**ASSESSMENT OF HYDROLOGICAL
IMPACTS OF PROPOSED BORROW PIT
AT SALBRI MIRE, ANGLESEY**

Report to S G S Environment

January 1995

Figure 1 Location plan. Five dry valleys draining towards the southern edge of the mire are indicated by arrows.

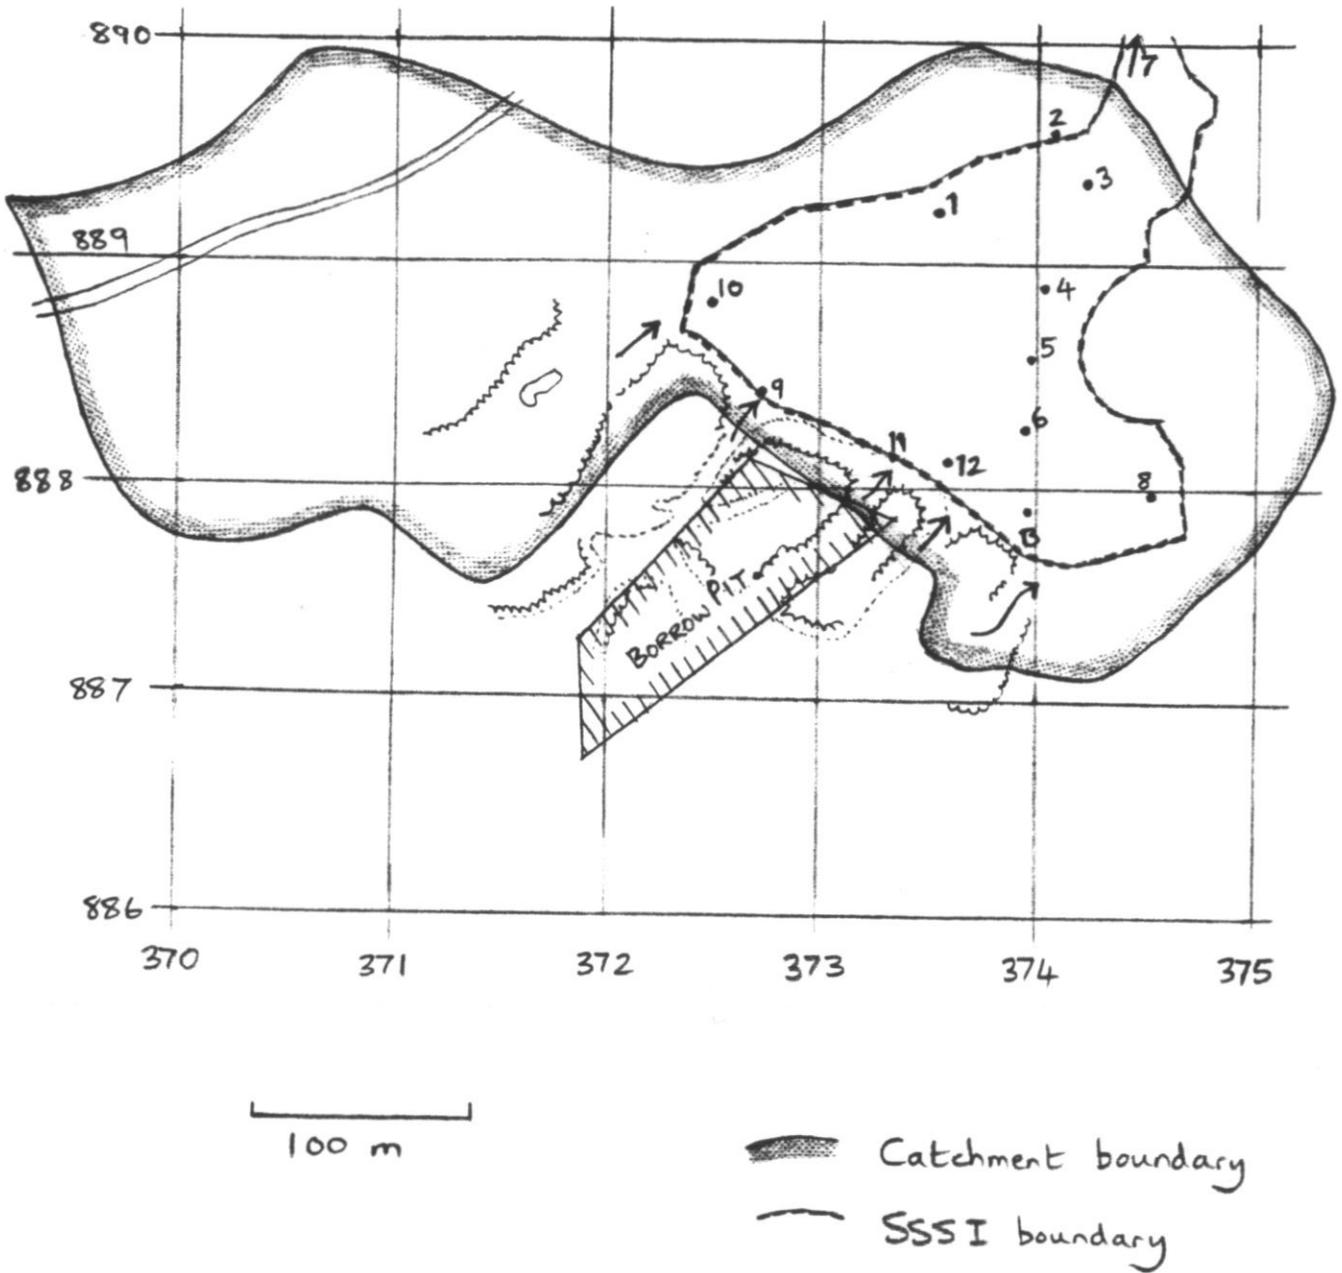
The borrow pit as indicated on the map dated November 1994 (see Figure 1) appears to cross the catchment boundary at its north-eastern corner. The pit should be re-positioned so that its northern edge falls at least 10 m outside the topographic catchment of the mire. This is particularly important in the dry valleys, and it is recommended that the delineation of the catchment boundary carried out as part of this study should be confirmed for each of the dry valleys by a levelling survey to find the highest point in the profile of each valley and mark it on the ground before the final outline for the borrow pit is decided.

Figure 2 (a) pH and (b) conductivity measurements. Circles indicate sample stations.

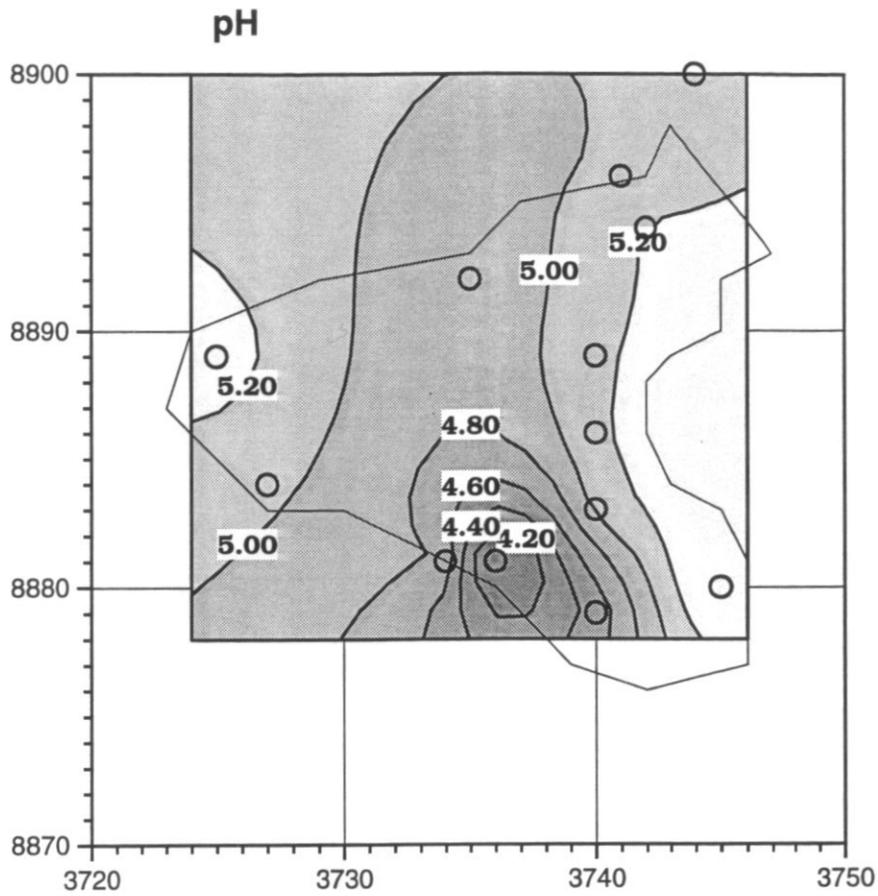
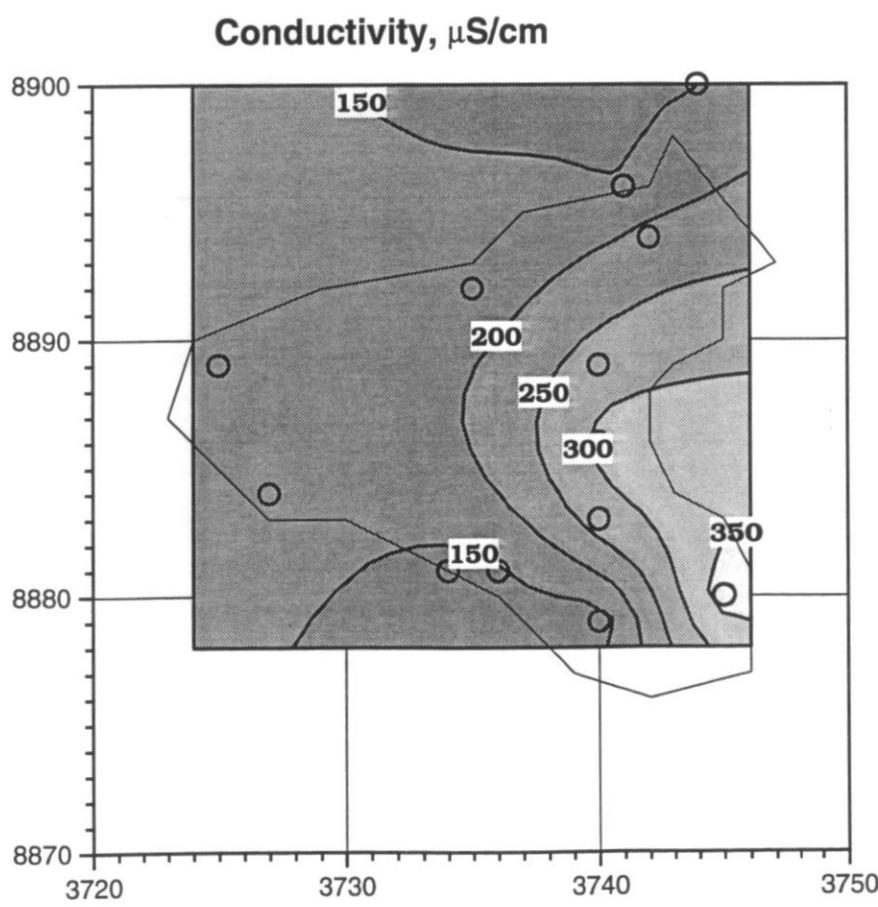
Both conductivity and pH data support the initial classification of Salbri as an acidic mire, with no obvious point groundwater input. Figure 2 shows contour plots of both determinands, with sampling stations and the SSSI boundary also plotted. It should be noted that the lack of sampling stations in the centre of the mire gives little control of contours in the central region, but it is possible to draw two interesting conclusions from the results:

- i) there is an area of low pH near the southern margin of the SSSI, and areas of quite high pH to the east and west of the site
- ii) the low pH area is also picked out by conductivity measurement, and there is water of higher conductivity along the eastern edge of the site.
